ADDENDUM 3

Contract: 24-C-00032; TPD Howard Avenue Annex Building

## City of Tampa | TPD Howard Avenue Annex Building

### Revision 3, CoT Addendum 3 – Bid RFI Responses

1 TECHNOLOGY OVERALL FLOOR PLAN  
3/32" = 1'-0"

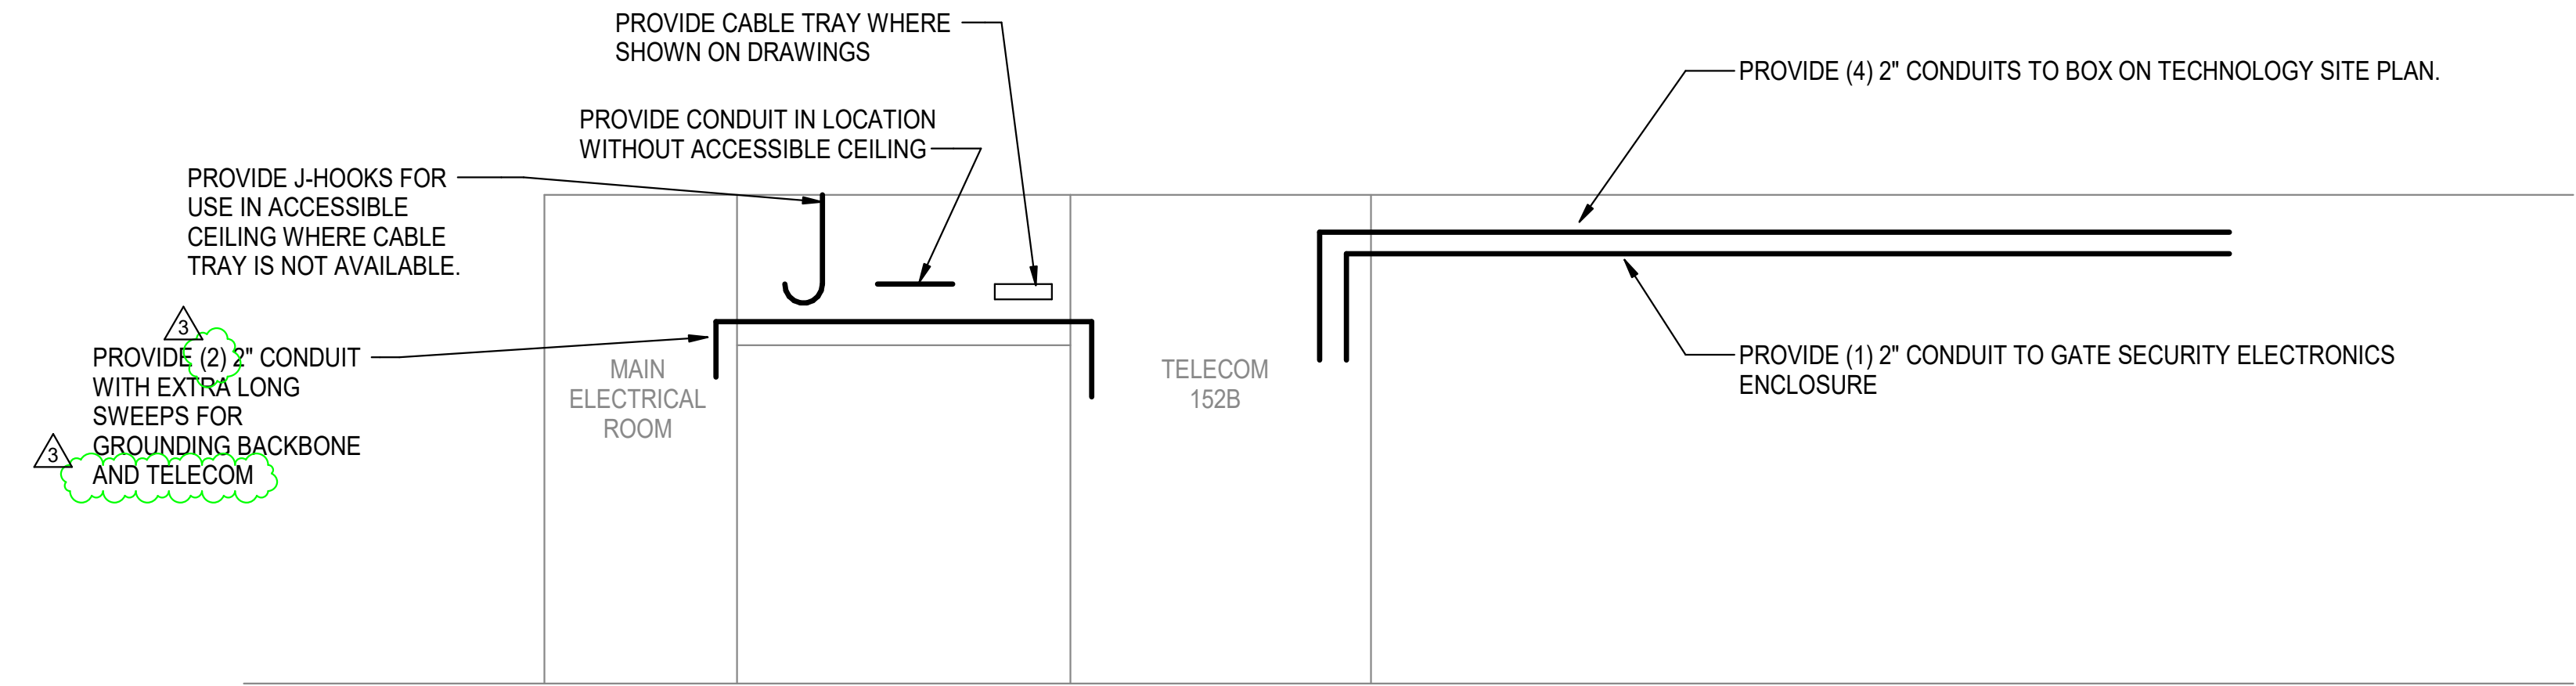
**Item 5 Drawings: T100 (RE-Issued)**

- Room with IT rack indicated.

23	11/21/2025	Burke Construction	Technology Clarifications	Technology Page T100 shows some kind of 12”x4” rack or duct, please confirm as what’s drawn does not match anything in the legend. Also, there is a 12”x4” Ladder rack cable tray on page T401, but is drawn different than what is shown on T100. Please confirm if these are the same designation.	TLC	Details for 12" x 4" cable tray referenced on T100 are shown on "T711- VOICE / DATA DETAILS"	TLC - Sheet T711, Detail 1 references Basket Style Cable Tray, which is the cable tray shown on sheet. Cable tray shown on sheet T401 is ladder rack. Ladder rack should be mounted similarly to detail T711, Detail 1.	12/1/2025	CLOSED
24	11/21/2025	Burke Construction	80KW Portable Generator referenced on E-501	Please advise if the 80KW Portable Generator will be by the City or if it should be included in our proposal. If we are to include can specifications be provided for this. If not, is it safe to assume we are to only allow for connections and disconnects.	SGM, CoT		SGM - Yes, it is assumed this will be by the city. All other MTS/ ATS/ disconnects are to be provided. The intent is to have availability for the generator to be pulled up and simply connected to the MTS that will be in place.	11/24/2025	CLOSED
